**MANDATORY****SEL-24-11****TITLE**

ELECTRICAL POWER - TRANSMITTAL OF CONTINENTAL AEROSPACE TECHNOLOGIES CRITICAL SERVICE BULLETIN CSB19-06

# **ALERT SERVICE BULLETIN**

## **Alternator Castellated Hex-Nut Inspection**

Figure 1 - Alternator, Typical - Continental Aerospace Technologies

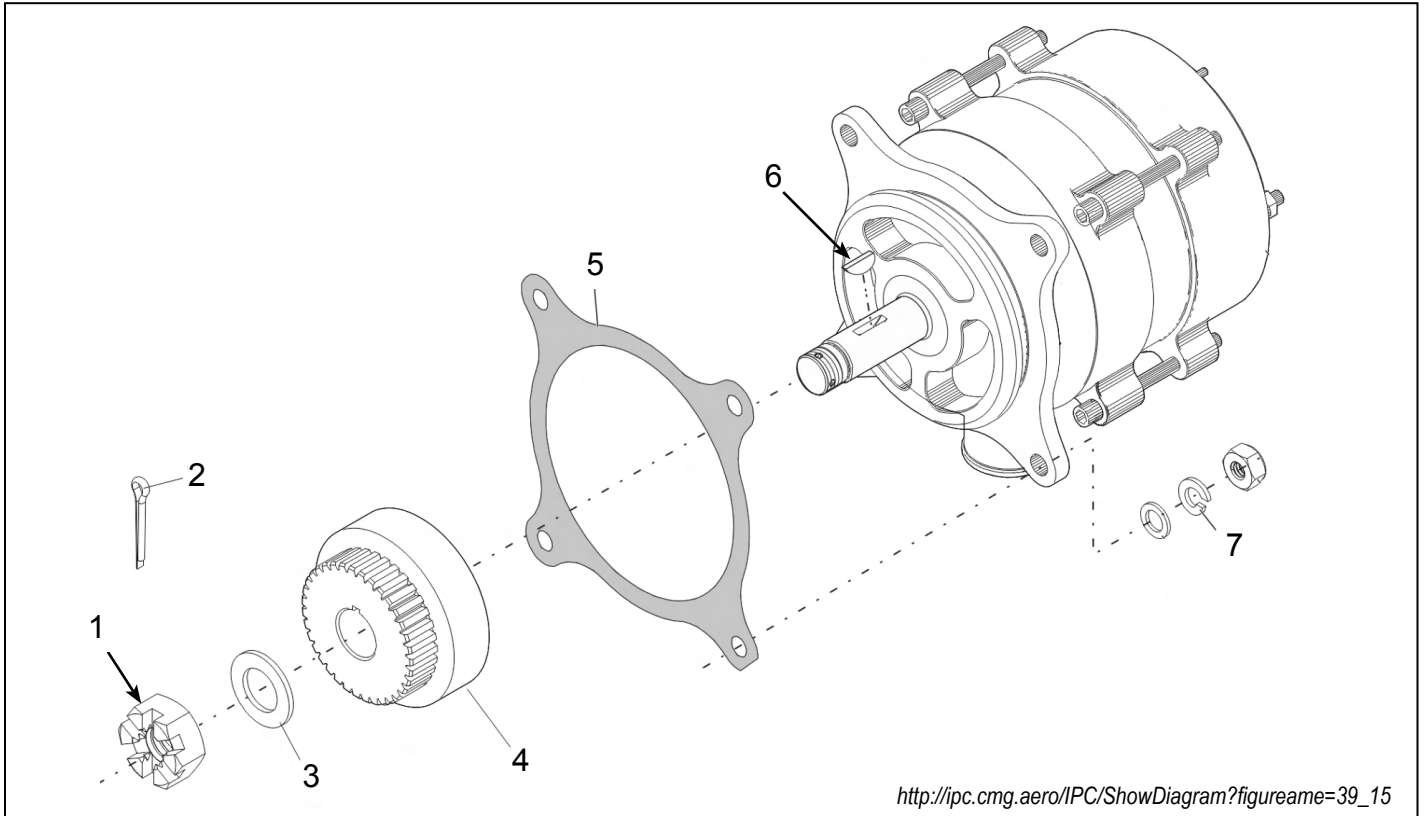
- (1) Alternators listed in section 1.A could contain a castellated hex-nut (1, Figure 1) that does not torque flush with the thrust washer (3). This condition could compromise the integrity of the drive coupling retention system.
  - (a) Loss of drive coupling retention may result in engine damage and/or unexpected loss of engine power.
- (2) This ASB is to advise the field of a known condition and to supply inspection criteria to identify affected alternators.

- (5) Remove and discard from alternator; cotter pin (2), castellated hex-nut (1), thrust washer (3), and woodruff key (6). Refer to Figure 1.
- (6) Inspect drive coupling (4) in accordance with applicable service instructions.
- (7) Install new replacement components not affected by this ASB onto the alternator in accordance with applicable engine manufacturer's maintenance manual. Refer to Table 1 - Materials Required.

Figure 4 - Roll-Stamped "AD"

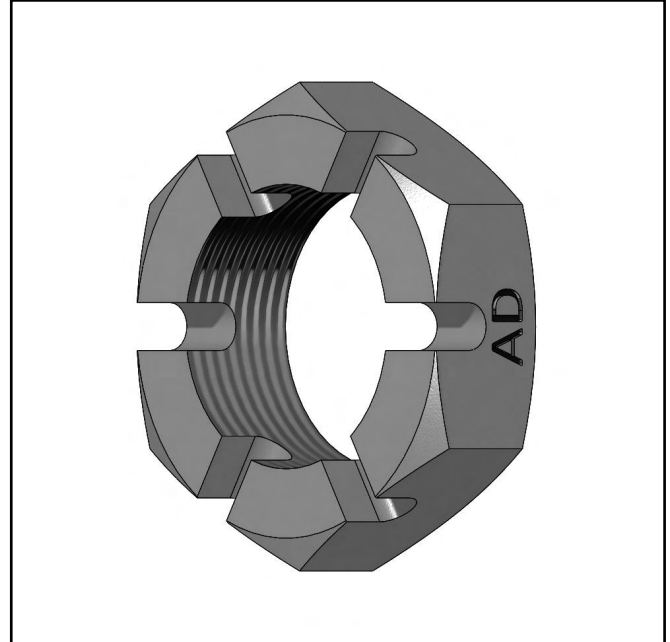
- B. Revise 3.B.2.(c) to reflect change to Figure 4:
    - (1) Change to: Hex-nut (1) is roll-stamped with the letters “**AD**”.
  - C. Add task 3.B.(6) for clarification:

- (1) Inspect drive coupling (4) in accordance with applicable service instructions.
  - D. Change Figure 4 from Machined Groove to Roll-Stamped “AD” and update illustration.

Figure 5 - Center-Punch Mark

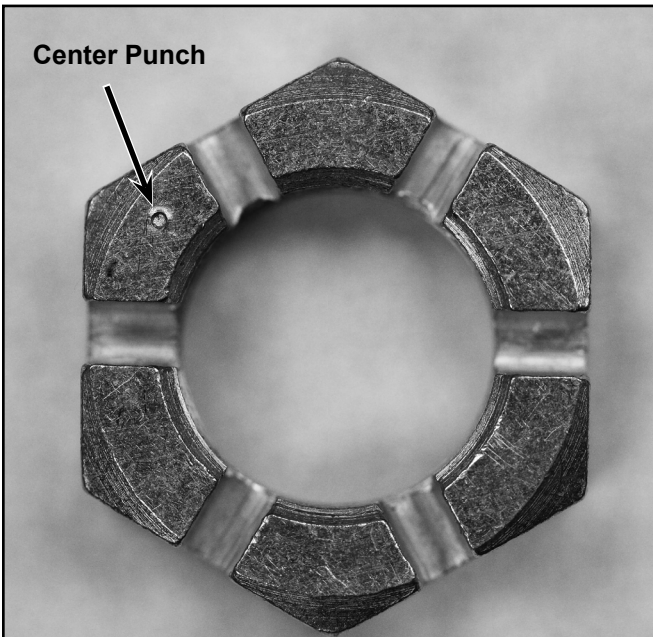
- (a) If the measurement at any nut flat is  $\geq$  .002 in. (.0508 mm), continue to 3.B.(5).
- (b) If the measurement at each nut flat is  $<$  .002 in. (.0508 mm), no corrective action is required.
  - 1) Using an automatic center punch, punch the face of the hex-nut (1) so that it will be easily identified for future reference (Refer to Figure 5). Continue to 3.B.(8).

Figure 6 - Gap Measurement

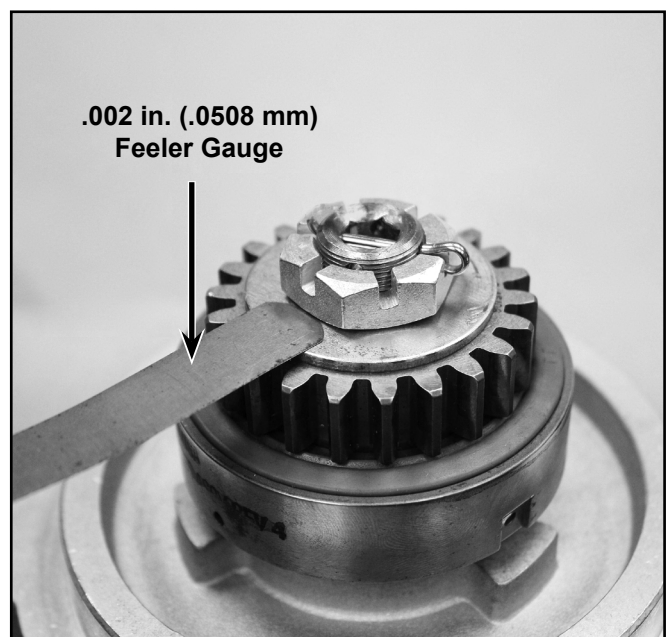
- (1) Remove the alternator from the engine in accordance with the latest revision of the aircraft and/or engine manufacturer's maintenance manual.
- (2) Inspect castellated hex-nut (1). If one the following indicators is present, the alternator is in compliance with this ASB. Refer to Figures 3 thru 5.
  - (a) Hex-nut (1) is laser etched with the letter "H";
  - (b) Hex-nut (1) is stamped with a center-punch;
  - (c) Hex-nut (1) is roll-stamped with the letters "AD".
- (3) If any indicator stated above **is not** present, proceed to 3.B.(4). If one of the indicators stated above **is** present, continue to 3.B.(8).
- (4) Using a .002 in. (.0508 mm) feeler-gauge, measure the gap between the nut thrust face and the thrust washer at each of the six hex-nut flats. Refer to Figure 6.
